State Route 131 Capital Preventive Maintenance Project (SCH# 2023090705)

Initial Study with Negative Declaration

January 2024

The Draft IS/ND was circulated to the public for 36 days between September 29, 2023 and November 3, 2023. Caltrans received 254 comment submittals. Responses to these comments are included in Appendix G. Throughout this document, a vertical line in the margin indicates a change made since the Draft IS/ND was circulated for public review. Minor editorial changes and clarifications are not so indicated.

FIGURE 2-1
Map 13 of 36 - Western Segment
Project Components
 State Route 131 Capital
 Preventive Maintenance Project
 EA 04-1Q230, MRN-131-0.00/4.40
 Marin County, California

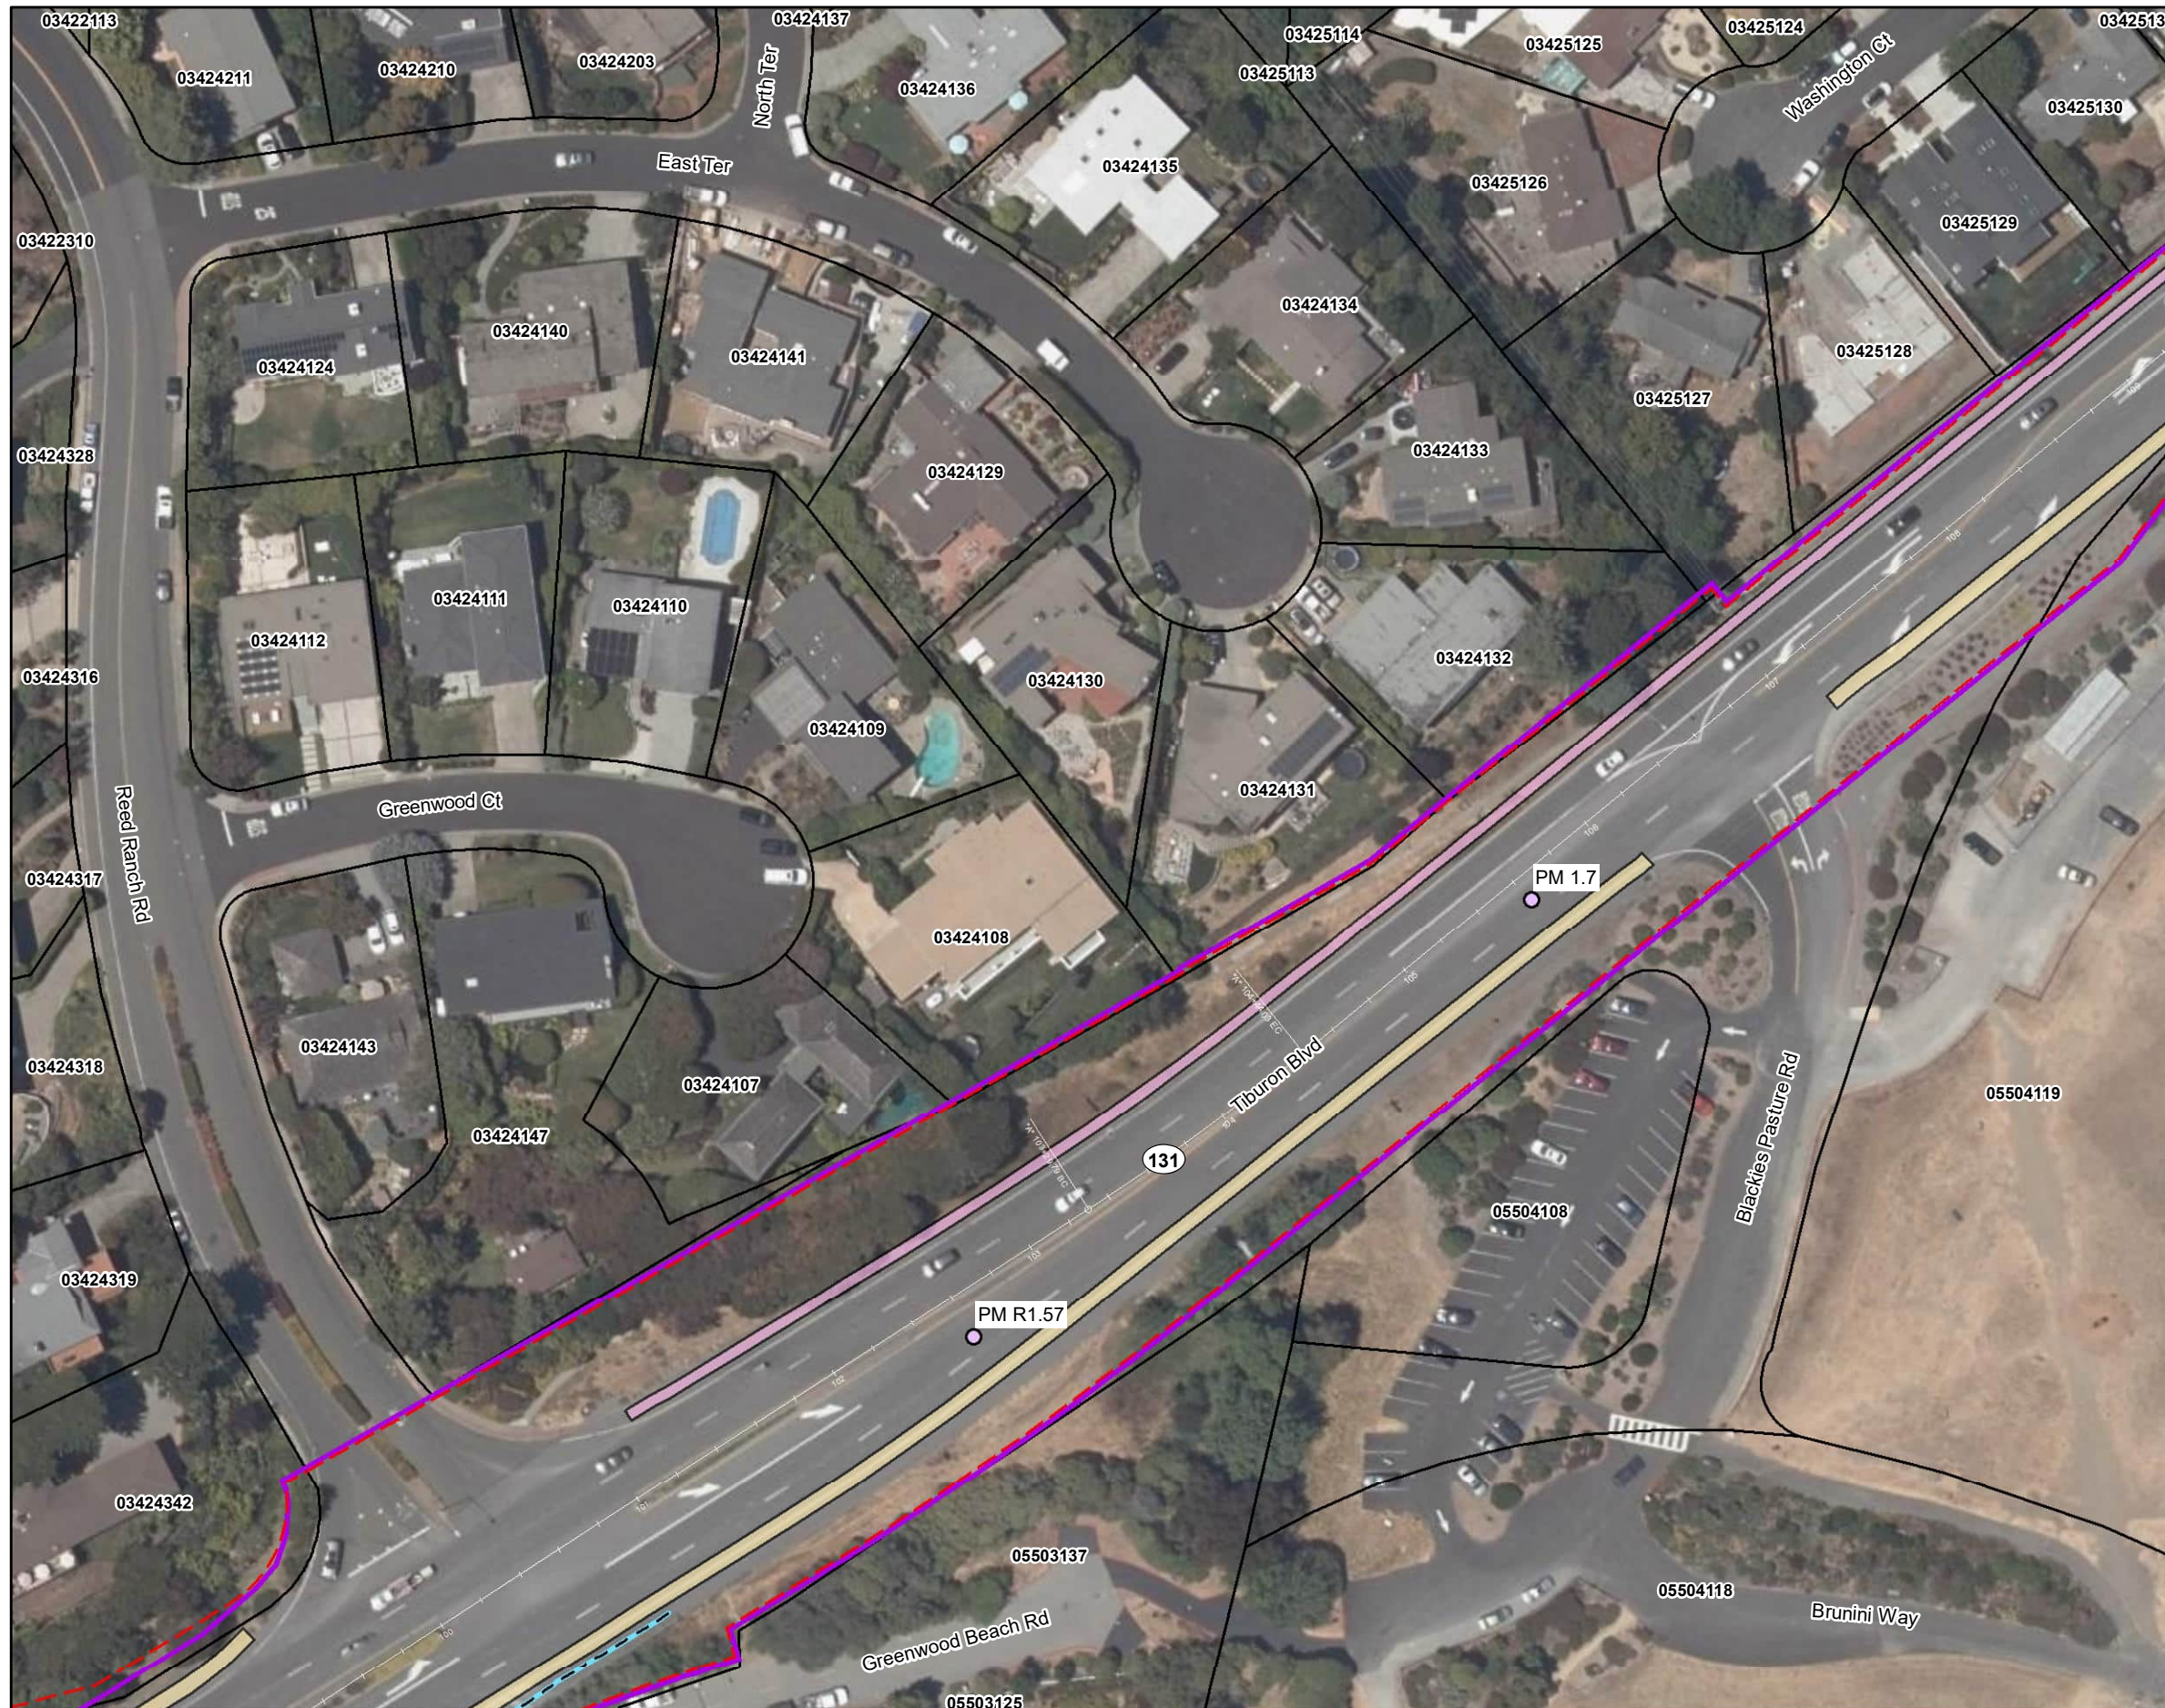
141	3	1-Nov-23	Kelly Voltz	B1 – Westbound Bikeway Gap Figure 2-1, Map 13 depicts what appears to be a gap in the westbound bikeway between the intersections of Jefferson Drive and Reed Ranch Road, directly across from the entrance to Blackie's Pasture. While such a gap is likely proposed due to a short narrowing of the roadway, we strongly urge that a design be developed that would not force westbound bicyclists to merge with high speed automotive traffic, given that prevailing speeds are often upwards of 45 mph.	Caltrans acknowledges your concern with bicycle safety between the intersections of Jefferson Drive and Reed Ranch Road, directly across from the entrance to Blackie's Pasture. Updates have been made to the project design that would widen the narrow section. Additionally, a Class II bikeway would be constructed between the intersections of Jefferson Drive and Reed Ranch Road along the westbound side of SR 131.

228	4	2-Nov-23	Dvera Hadden	B1 - Westbound Bikeway Gap Figure 2-1, Map 13 depicts what appears to be a gap in the westbound bikeway between the intersections of Jefferson Drive and Reed Ranch Road, directly across from the entrance to Blackie's Pasture. While such a gap is likely proposed due to a short narrowing of the roadway, we strongly urge that a design be developed that would not force westbound bicyclists to merge with high speed automotive traffic, given that prevailing speeds are often upwards of 45 mph.	A Class II bikeway is proposed for westbound direction from Jefferson Drive to Reed Ranch Road to address the existing gap in the active transportation network between Trestle Glen Boulevard and Reed Ranch Road.
228	5	2-Nov-23	Dvera Hadden	B2 - Eastern Terminus of Westbound Bikeway Figure 2-1, Map 15 depicts the westbound bikeway having an eastern terminus at Jefferson Drive. This is a safety issue particularly for westbound riders coming from the northern terminus of the Old Rail Trail. While eastbound riders using the new Tiburon Boulevard bikeway may exit at the entrance to Blackie's Pasture, westbound riders coming from the Old Rail Trail hoping to use the Tiburon Boulevard bikeway will not be able to turn left at the Blackie's Pasture entrance (which is unsignalized) and will instead be forced to use the intersection at Trestle Glen, and then continue west for 300' before the Class IV bikeway begins. We recommend that the westbound bikeway be extended to Trestle Glen Boulevard.	Thank you for your interest in the SR 131 Capital Preventive Maintenance Project. Caltrans acknowledges the recommended designs that were submitted with your comments. However, the recommendations to the project design are beyond the scope of the Project and cannot be included as a project component. Because this comment does not raise a significant environmental issue associated with the proposed project no further response is required.

FIGURE 2-1
Map 15 of 36 - Central Segment
Project Components
 State Route 131 Capital
 Preventive Maintenance Project
 EA 04-1Q230, MRN-131-0.00/4.40
 Marin County, California

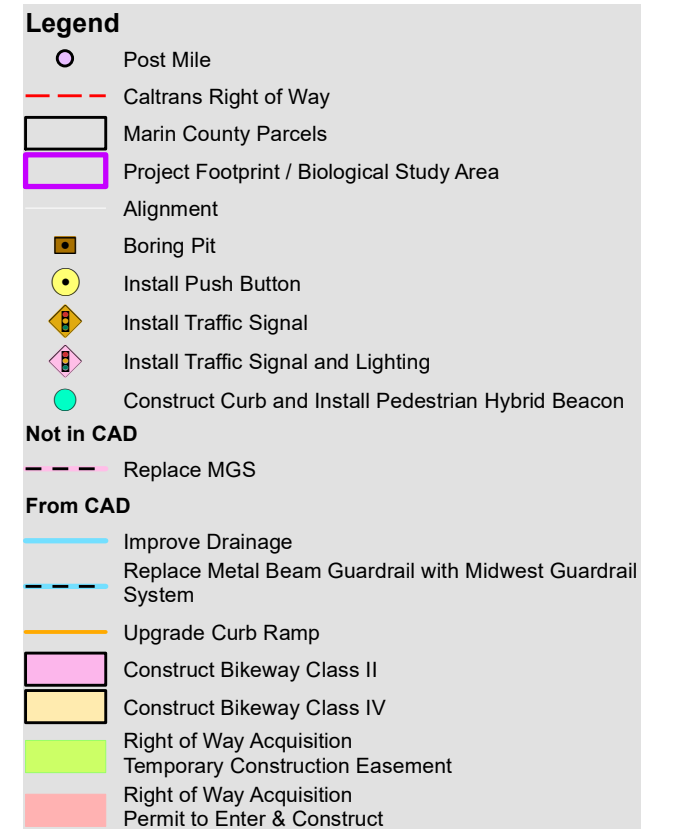
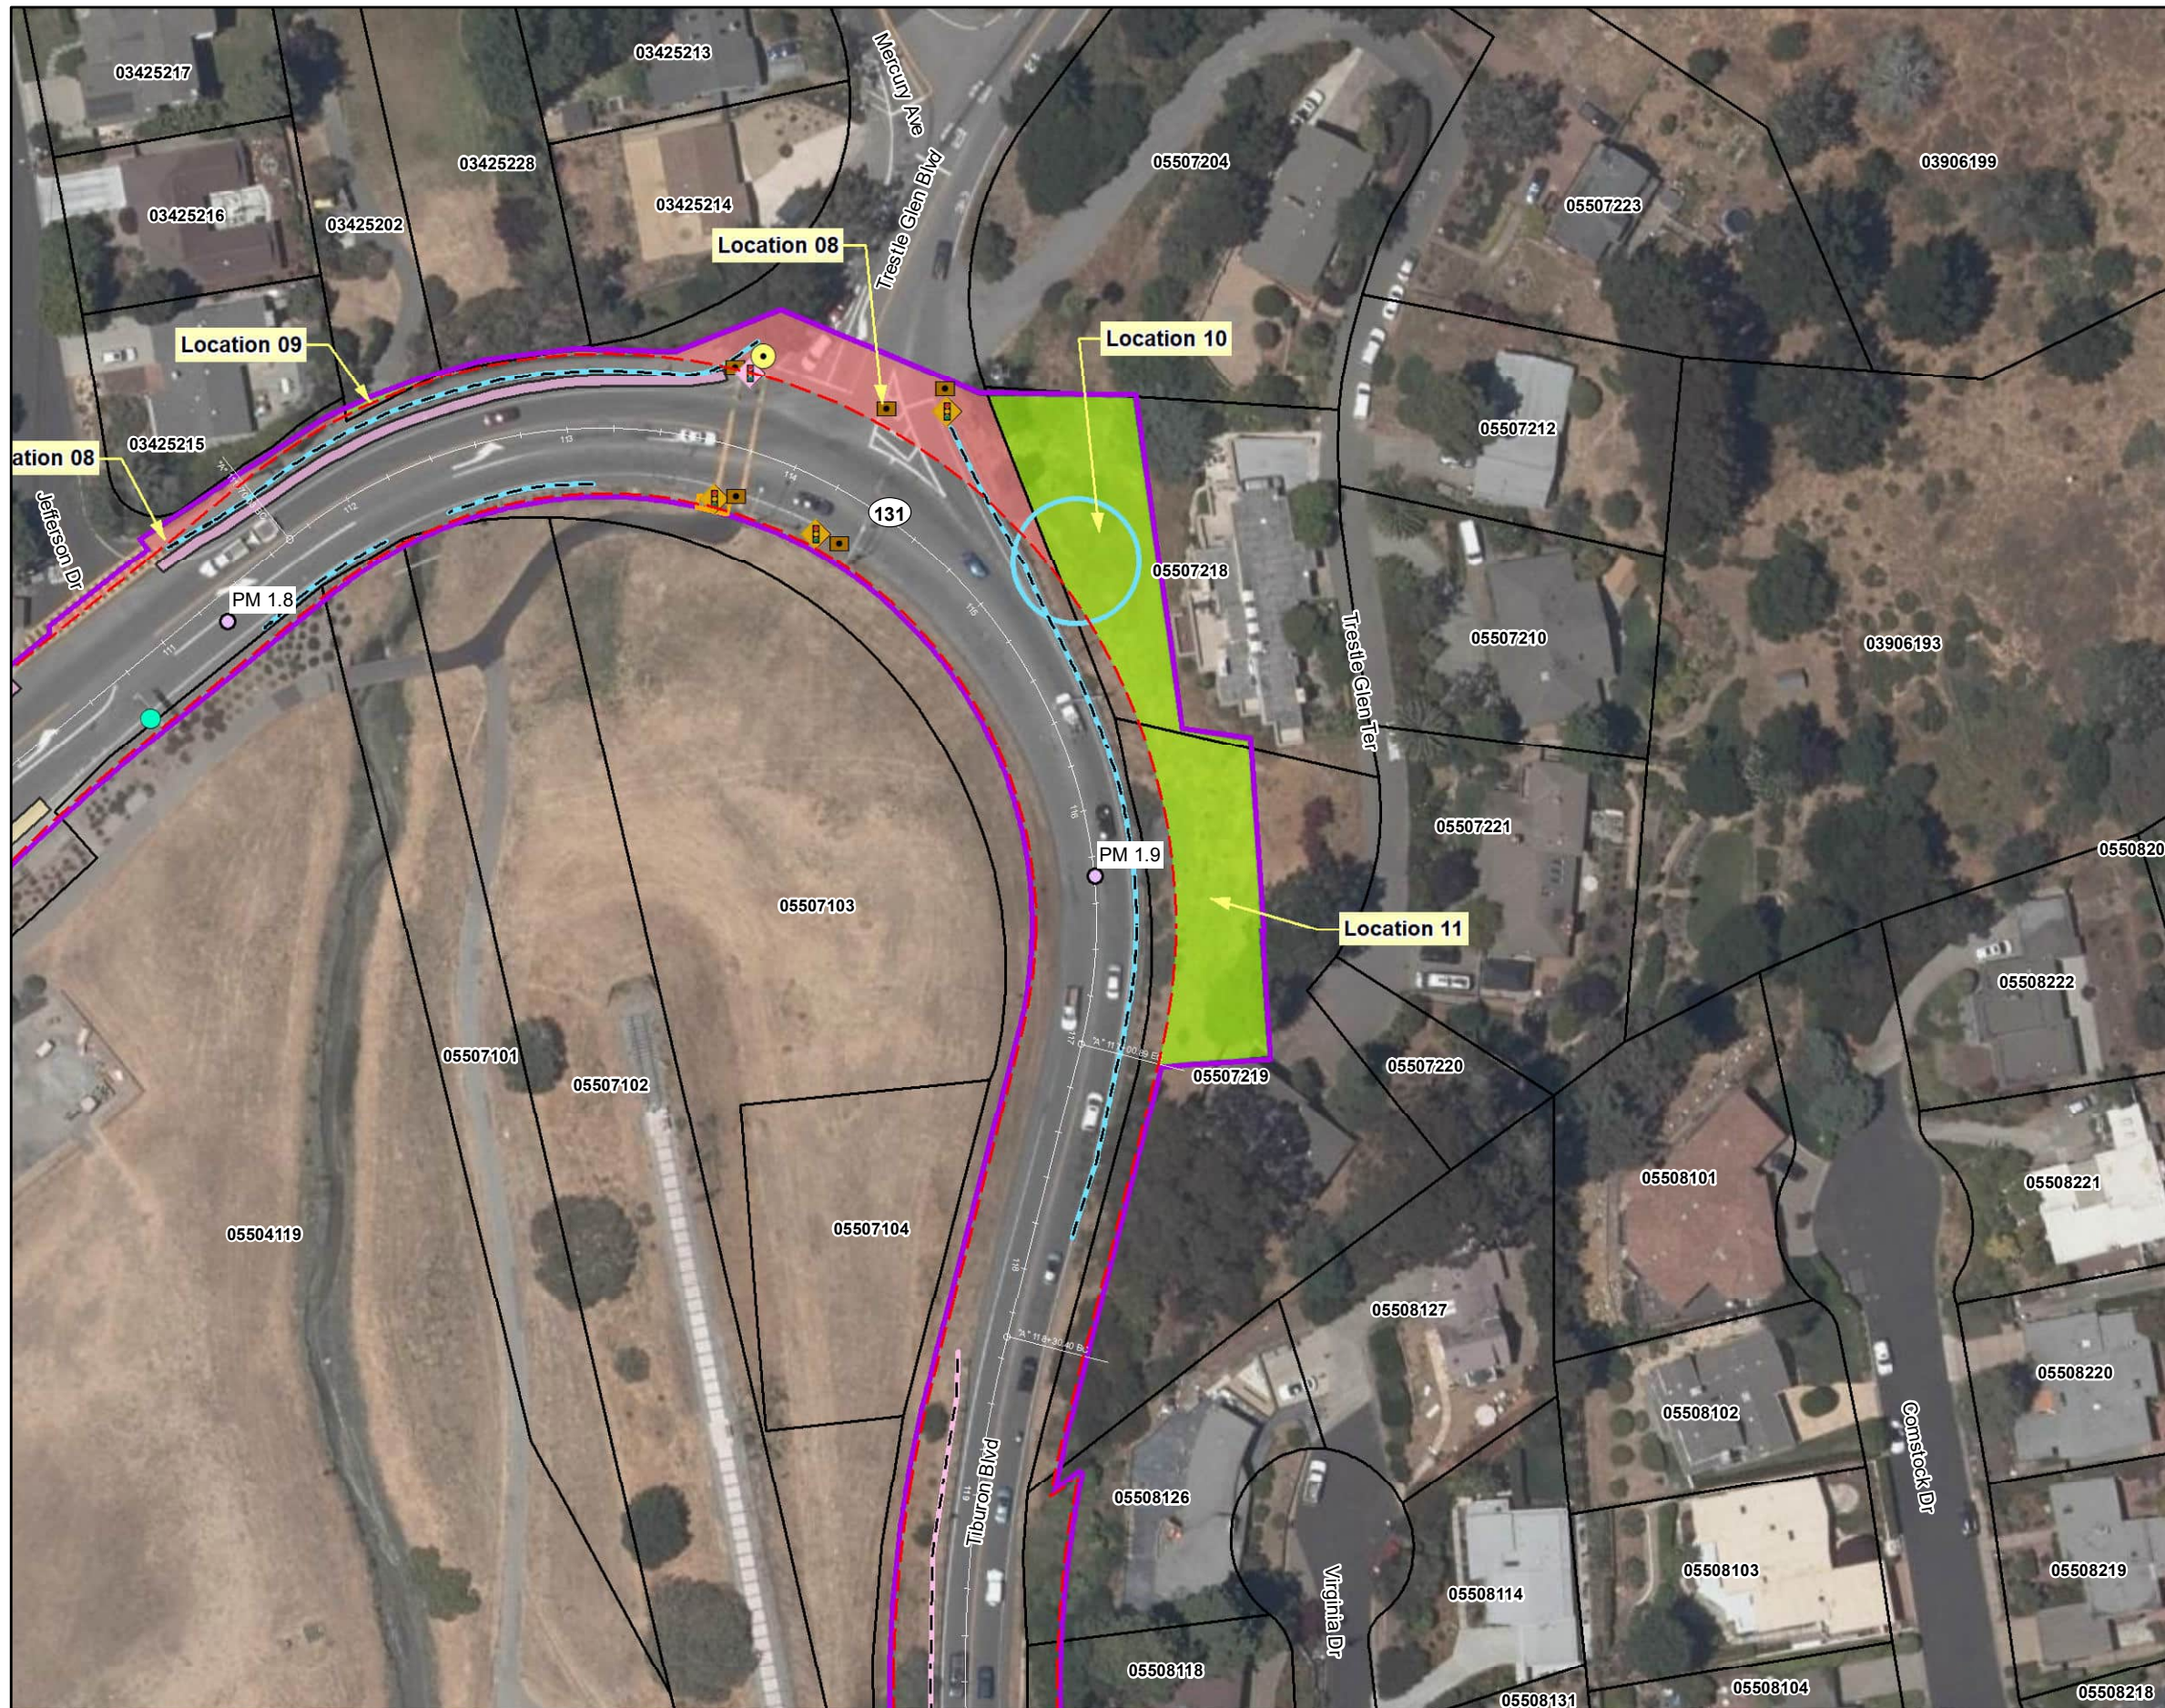
141	4	1-Nov-23	Kelly Voltz	B2 – Eastern Terminus of Westbound Bikeway Figure 2-1, Map 15 depicts the westbound bikeway having an eastern terminus at Jefferson Drive. This is a safety issue particularly for westbound riders coming from the northern terminus of the Old Rail Trail. While eastbound riders using the new Tiburon Boulevard bikeway may exit at the entrance to Blackie's Pasture, westbound riders coming from the Old Rail Trail hoping to use the Tiburon Boulevard bikeway will not be able to turn left at the Blackie's Pasture entrance (which is unsignalized) and will instead be forced to use the intersection at Trestle Glen, and then continue west for 300' before the Class IV bikeway begins. We recommend that the westbound bikeway be extended to Trestle Glen Boulevard.	Caltrans acknowledges your concerns regarding bicycle safety within the project corridor, specifically at the intersection of Trestle Glen Road and SR 131. The construction of a Class II bikeway along the westbound site of SR 131 between Trestle Glen Road and Reed Ranch Road has been included in the Project scope.

206	3	2-Nov-23	Marin County Bicycle Coalition	<p>B2 – Eastern Terminus of Westbound Bikeway Figure 2-1, Map 15 depicts the westbound bikeway having an eastern terminus at Jefferson Drive. This is a safety issue particularly for westbound riders coming from the northern terminus of the Old Rail Trail. While eastbound riders using the new Tiburon Boulevard bikeway may exit at the entrance to Blackie's Pasture, westbound riders coming from the Old Rail Trail hoping to use the Tiburon Boulevard bikeway will not be able to turn left at the Blackie's Pasture entrance (which is unsignalized) and will instead be forced to use the intersection at Trestle Glen, and then continue west for 300' before the Class IV bikeway begins. We recommend that the westbound bikeway be extended to Trestle Glen Boulevard.</p>	<p>Thank you for your interest in the SR 131 Capital Preventive Maintenance Project. Caltrans acknowledges the recommended designs that were submitted with your comments. However, the recommendations to the project design are beyond the scope of the Project and cannot be included as a project component. Because this comment does not raise a significant environmental issue associated with the proposed project no further response is required.</p>
